BID CLARIFICATION MATERIAL

CELLNET

Subject: Cellnet BAFO response

Cellnet Response to PG&E Question 3-24-2005 Rev1

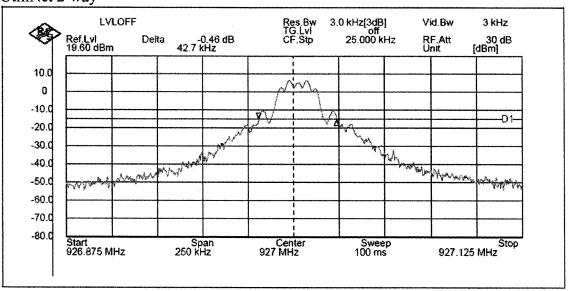
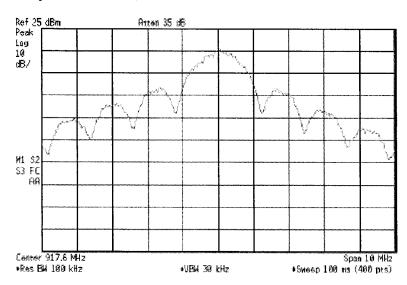
7 Provide a copy of your radio signal and the associated emission mask

- a. Meter to repeater
- b. Repeater into network
- c. Repeater to meter

UtiliNet 2-way

Cellnet 1-way

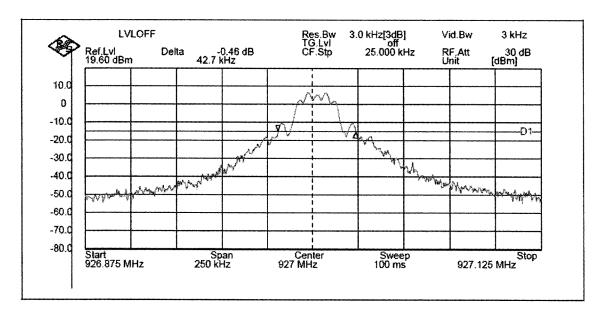
7 Provide a copy of your radio signal and the associated emission mask

- a. Meter to repeater
- b. Repeater into network
- c. Repeater to meter
